2019/07/19

MCDJ-Ø6/Ø10(-P) Configuration Change Notice

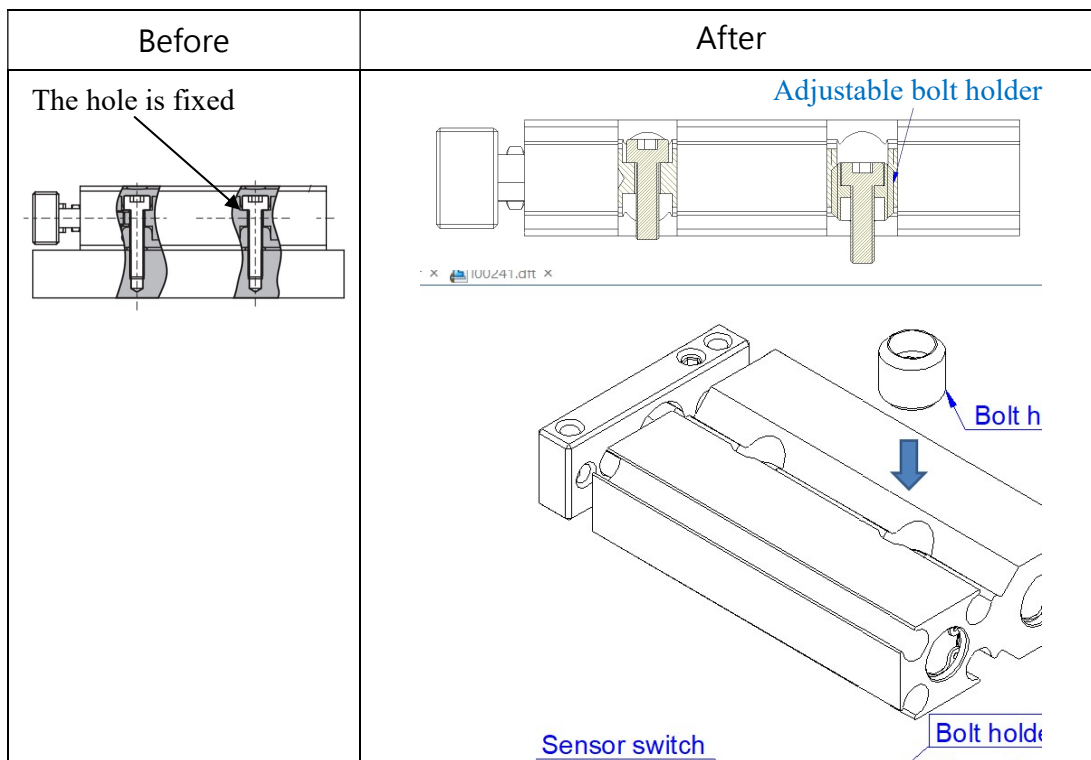
1. Model series
MCDJ-Ø6/Ø10(-P).
2. Design change reason
Optimize installation characteristic.
3. Design change
